Ref:	NR/L2/ELP/27009/MOD C40
Issue:	1
Date:	03/12/2011
Compliance date:	03/03/2012
Page	1 of 4

OVERHEAD LINE CAMPAIGN CHANGES – DATA SHEET

REPLACEMENT OF 'PEA SHOOTER' TYPE BI METAL CONNECTIONS TO AWAC CATENARY

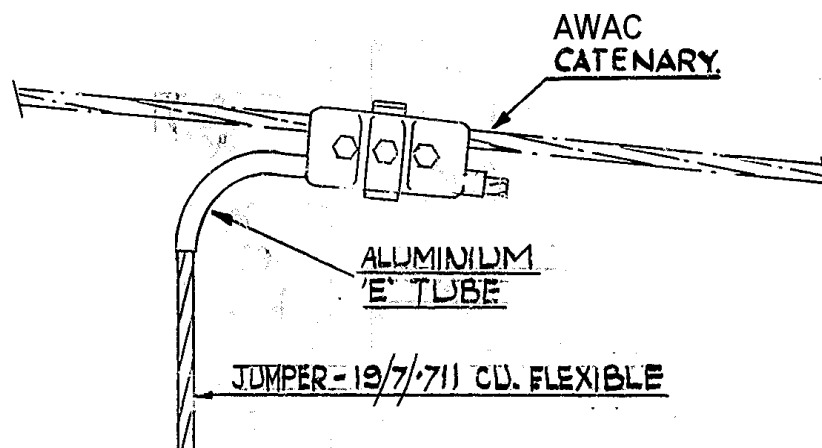
COMPONENT 'Pea shooter' bi metallic connector for AWAC catenary.

PROBLEM This type of connector is prone to dissimilar metal corrosion. This gives a high resistance connection which leads in turn to dropper and catenary damage.

Replace with 20mm diameter bi-metal spill rod and wedge clamp as follows:

Item	OLEMI	PADS
20mm spill rod	121/815/004	091/011862
Wedge clamp	121/813/002	091/002270
PG clamp	125/003/001	091/020699
